FAQ Number 13-0006 FAQ Revision 0

FAQ Title Modeling Junction Box Scenarios in a Fire PRA

Plant: Various Date: May 6 2013

Figure 14: Layout of physical analysis units used in the conceptual example

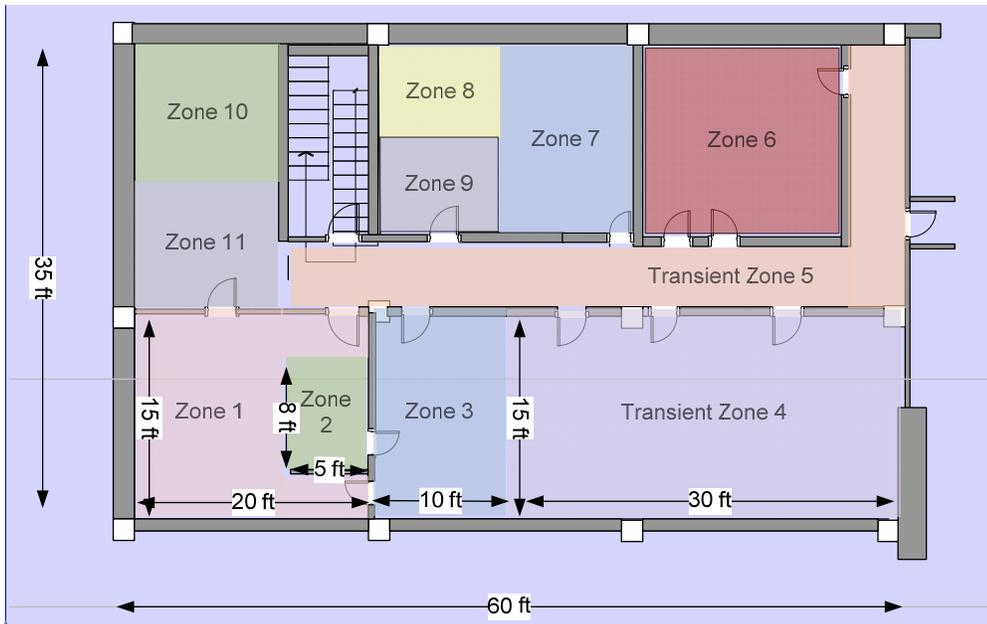
Comment [J12]: Figure no longer appropriate since not using transient zones.
